# Commission Agenda Report

Subject: De Minimis Waiver No. 24-007 – An application for a new onsite wastewater treatment system for a parcel affected by the Woolsey Fire

## ENVIRONMENTAL HEALTH REVIEW REFERRAL SHEET

## ENVIRONMENTAL HEALTH REVIEW SHEET

CITY OF MALIBU, COUNTY OF LOS ANGELES, STATE OF CALIFORNIA  
**ON-SITE SEWAGE DISPOSAL SYSTEM**  
APN 4469-004-017  
30051 ANDROMEDA LANE

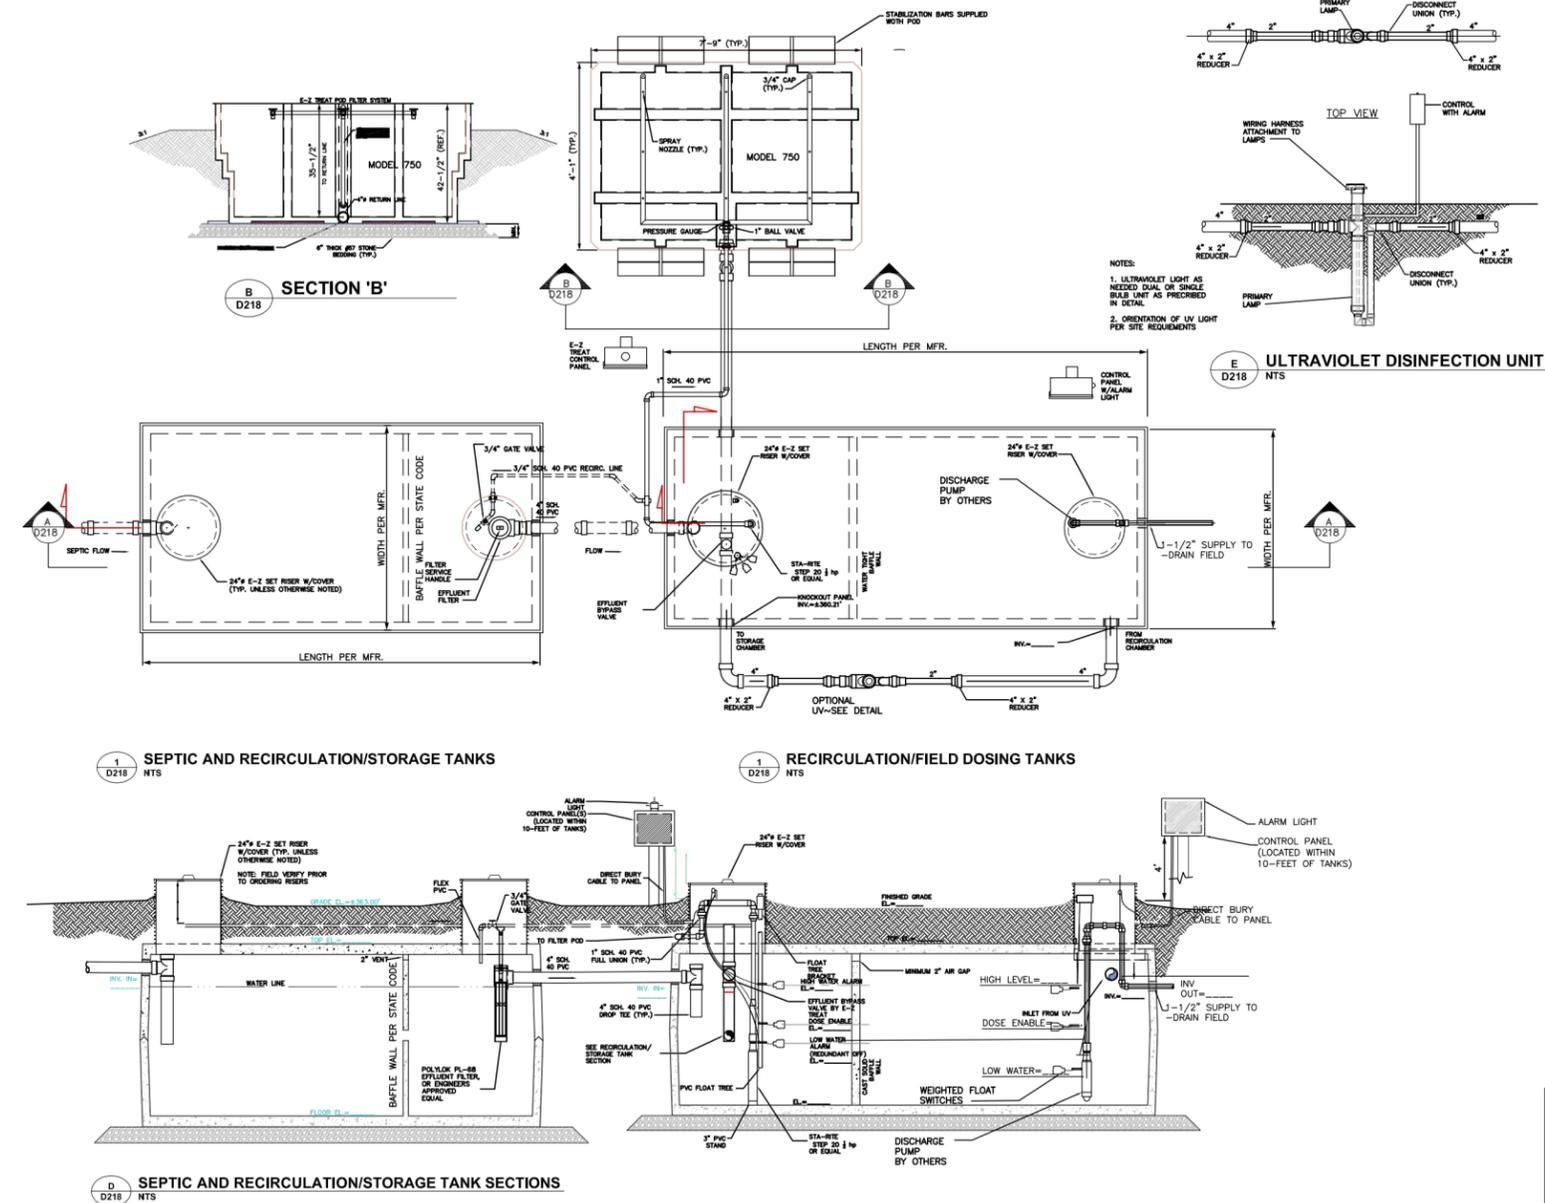
1. This conformance review is for a new advanced onsite wastewater treatment system (OWTS) to serve a fire rebuild of a single-family dwelling. The new advanced OWTS conforms to the requirements of the Malibu Municipal Code (MMC) and the Local Coastal Program (LCP).
2. The fire rebuild of the single-family dwelling will be approved under separate permit.
3. This review relates only to the minimum requirements of the MMC, and the LCP, and does not include an evaluation of any geological or other potential problems, which may require an alternative method of review treatment.
4. This review is valid for one year or until MMC, and/or LCP, and/or Administrative Policy changes render it noncomplying.
